PROJECT	Smithsonian Institution- Revitalization of the Historic Core (RoHC)	MEETING DATE	5/24/2023
ORGANIZER	Smithsonian Institution, Carly Bond (moderator)	TIME	2:30-4:30pm
LOCATION	Virtual/Zoom		
PANELISTS	Carly Bond- Smithsonian Institution Christopher Lethbridge- Smithsonian Institution Brenda Sanchez- Smithsonian Institution Lauren Brandes- Smithsonian Gardens Matthew Chalifoux, EYP-Loring Anthony Bochicchio, EYP-Loring Faye Harwell, Rhodeside and Harwell		
SUBJECT	Consulting Parties Meeting #13

MEETING MINUTES

Purpose – This was Consulting Parties Meeting 13 for the Revitalization of the Historic Core (RoHC) project of the Smithsonian Institution. The meeting was held in compliance with Section 106 of the National Historic Preservation Act.

Walkway railing visibility from the middle of the National Mall.

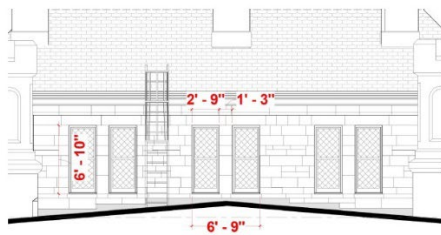
6. **Q:** Is it possible to paint the railing a lighter color?

12. **Q:** The egress on the roof, I imagined that the railing could be less visibly intrusive. Have you studied anything that has less structure? Do we have to have pickets that close together or that wide? Can we use wiring or something less visually apparent?

R: Any color will be visible against the sky; some may argue that black is actually less visible. Due to the tonal qualities of the building, the design team suggests that black would be less noticeable.

- R:** Yes, we did look at alternatives, but the spacing of the guardrail elements per code is a maximum of 4", the height must be a minimum of 42". If you are thinking about a wired or aircraft cable type system, the wires are also dense (to achieve 4" spacing).

- When the spacing is every 4" there is visual density, but this is a system meant to protect people in an emergency who are fleeing the building and crossing the roof. We looked at other options, but they introduced a material/vocabulary that was foreign to this building. The Smithsonian's preferred approach is to keep with the historic materials of the building, and a utilitarian design for less of a visual impact. At earlier Consulting Party meetings, it was agreed that more contemporary interventions were inappropriate.
